Re: East Springfield-Tangy 138 kV Loop to Broadview Substation Project, Moorefield Township, Clark County, Ohio

**Subject: American Transmission Systems, Incorporated – A FirstEnergy Company  
Phleger Barn – Project Changes and Effects Recommendation  
East Springfield-Tangy 138 kV Loop to Broadview Substation Project  
Moorefield Township, Clark County, Ohio  
OHPO No. 2016-CLA-37051**

Summary: Application for Amendment to the East Springfield - Tangy 138kv Loop to Broadview Substation (Part 4 of 4) electronically filed by Mr. Robert J Schmidt on behalf of American Transmission Systems Inc.

**FIGURE 2**  
**APPENDIX E**  
**PHLEGER FARMSTEAD**

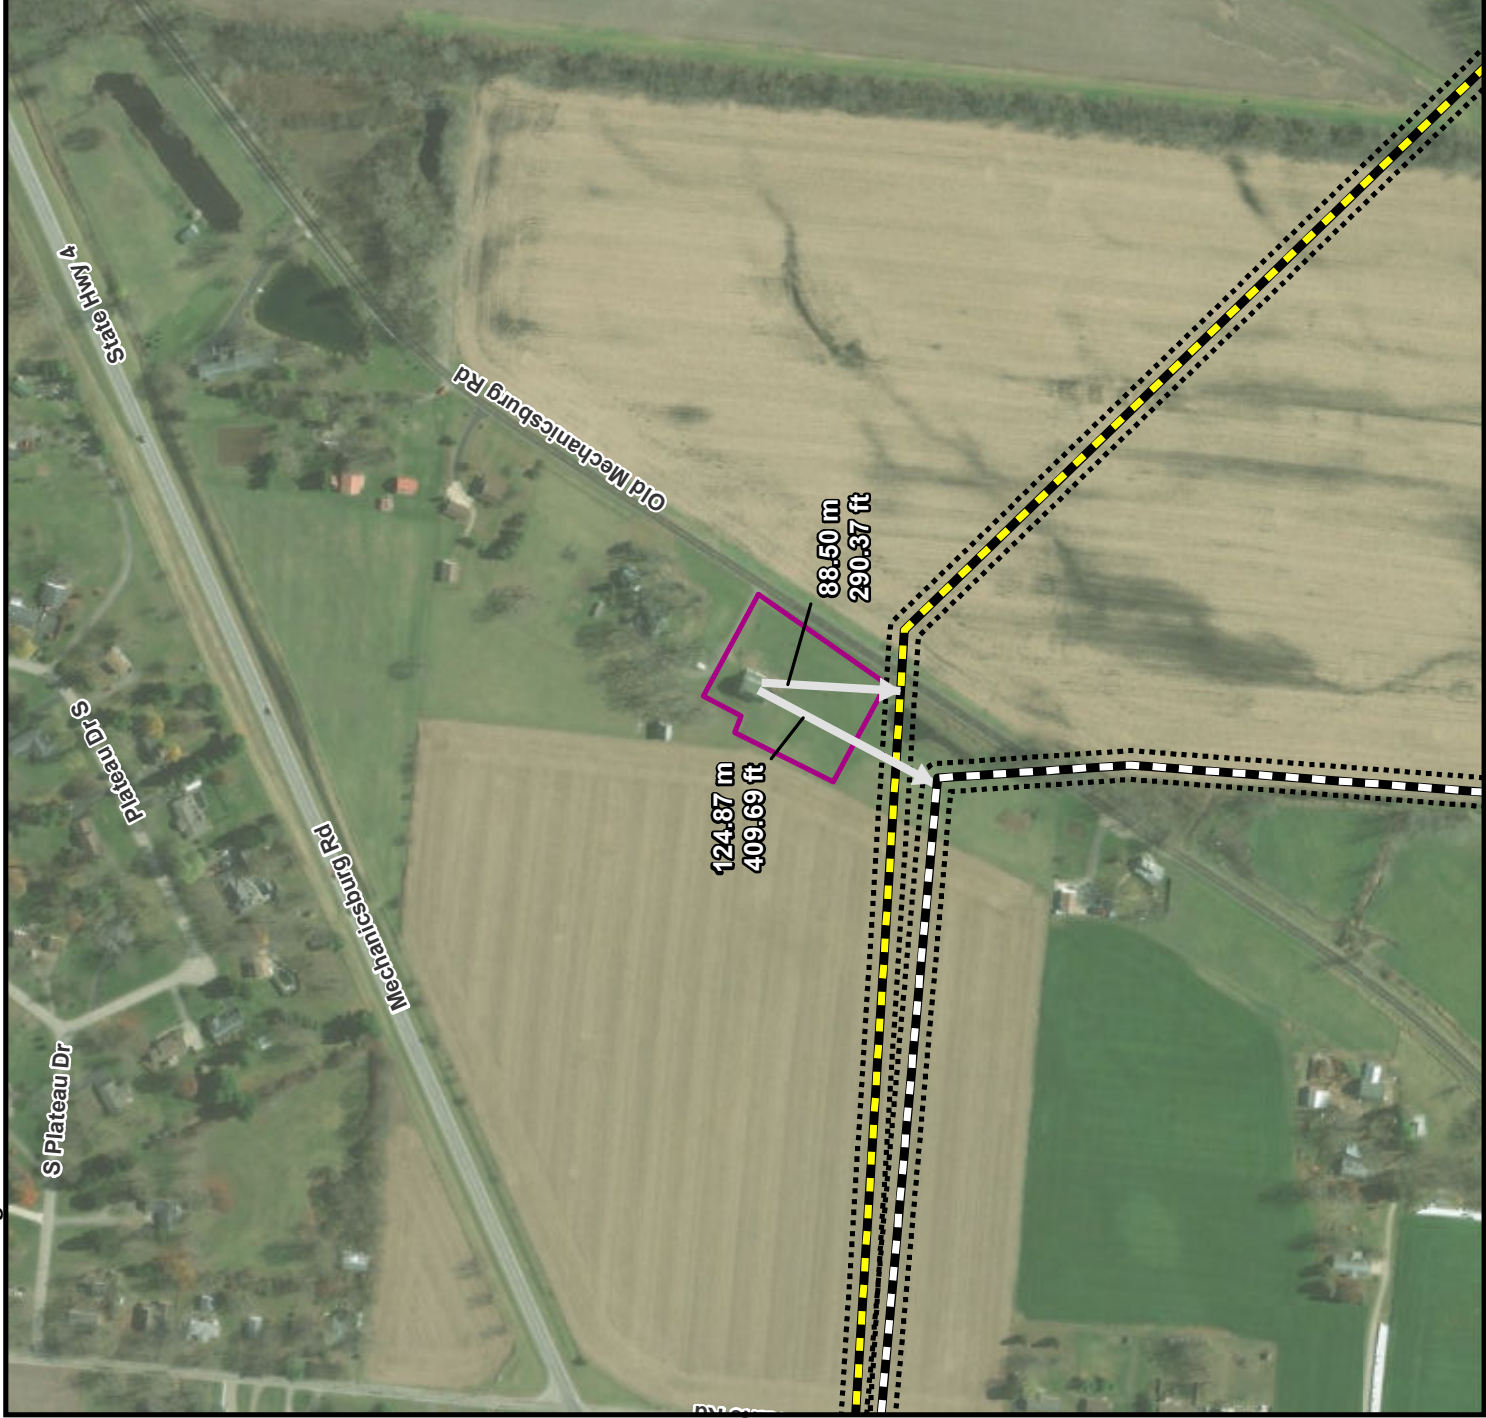
CH2M further recommended an NRHP boundary encompassing the barn and its immediate surroundings, beginning at a point running parallel to the south side of the existing driveway, to a point intersecting the plane of the fenced barnyard, following the fenceline in a generally southwesterly direction to a point of intersection with the plane of the fenceline's demarcation of a farm pond, running southeasterly to the fenceline marking the eastern edge of the barnyard, running in a northeasterly direction to its point of origin. The proposed boundary, which is inclusive of 1.84 acres (0.74 hectare), is depicted in Attachment 2, Figure 1. The OHPO concurred with this eligibility recommendation and proposed NRHP boundary in a response letter dated October 27, 2017. Additionally, the OHPO noted that as designed, the Project would result in an adverse effect to the resource, due to the alignment crossing an open agricultural field in its immediate viewshed.

**FIGURE 1**  
**PHLEGER FARMSTEAD**  
**AND PROJECT OVERVIEW**

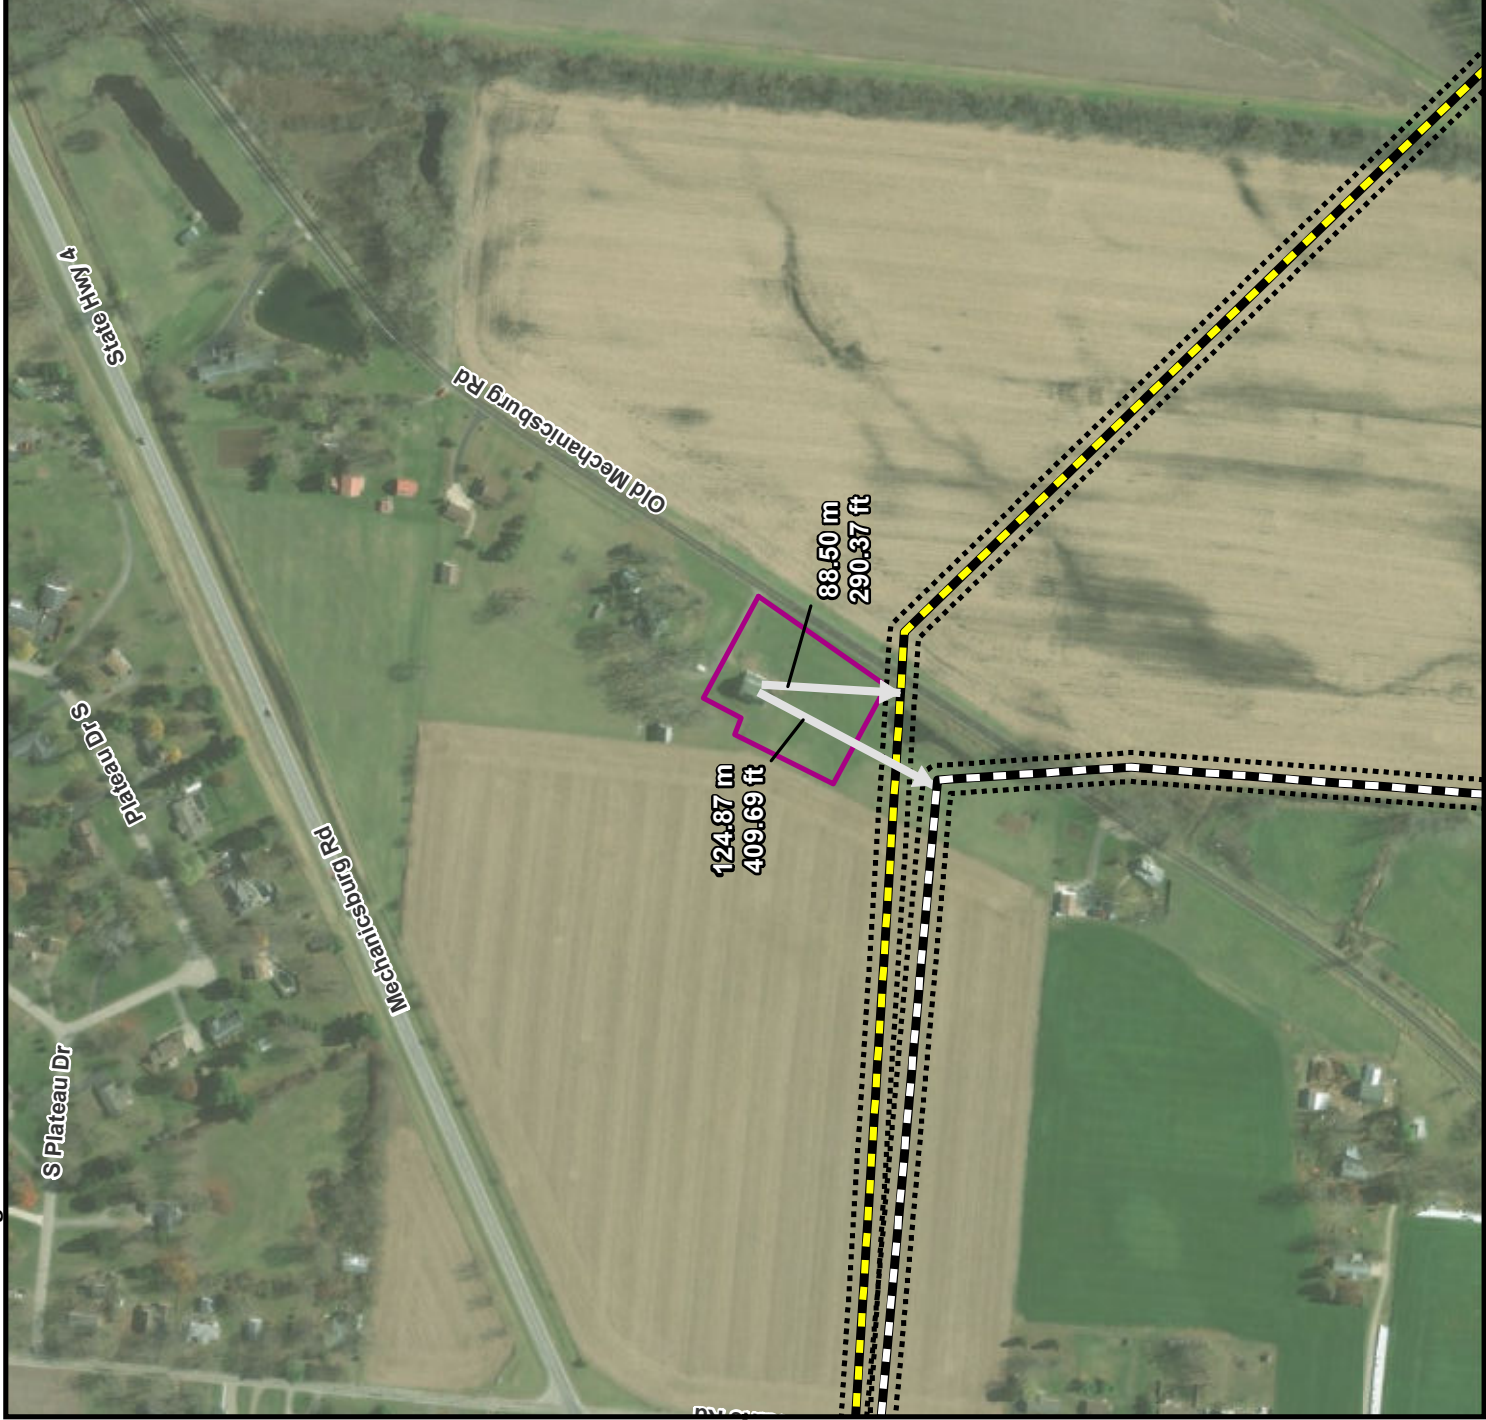
Subsequent to receipt of the OHPO's October 27, 2017 comments, ATSI revisited engineering design of the Project, in part to pre-emptively mitigate adverse effects to the NRHP-eligible Phleger Barn. As shown in Attachment 2, Figure 1, ATSI re-engineered the Project alignment to move proposed pole structures and conductors further from the resource, to allow for both additional topographical screening by the rise to the south and west of the barn, and to eliminate the crossing of an open agricultural field within the viewshed to the southeast. Importantly, the alignment will now extend parallel to and away from the gable end of the barn (a distance of 409 feet at its closest point), which is marked by a non-contemporaneous silo. Furthermore, ATSI proposes to use pole structures at the point of inflection (PI) south of the barn that blend with extant stands of trees. A sample photograph depicting an example of the proposed PI pole structures is included in Attachment 1, Photograph 4.

Considering the re-engineered alignment and use of pole structures that blend with the immediate surroundings, CH2M recommends that the redesigned Project will have No Adverse Effect to the NRHP-eligible Phleger Barn, and no further architectural and historical work is recommended for the Project. A conference call with OHPO Architectural Historian Mary Rody on April 3, 2018 confirmed that the OHPO considers the pre-emptive mitigation measures taken by ATSI to be sufficient in eliminating potential adverse effects to above-ground historic properties from the Project. CH2M and ATSI ask for your written concurrence with our recommendations.
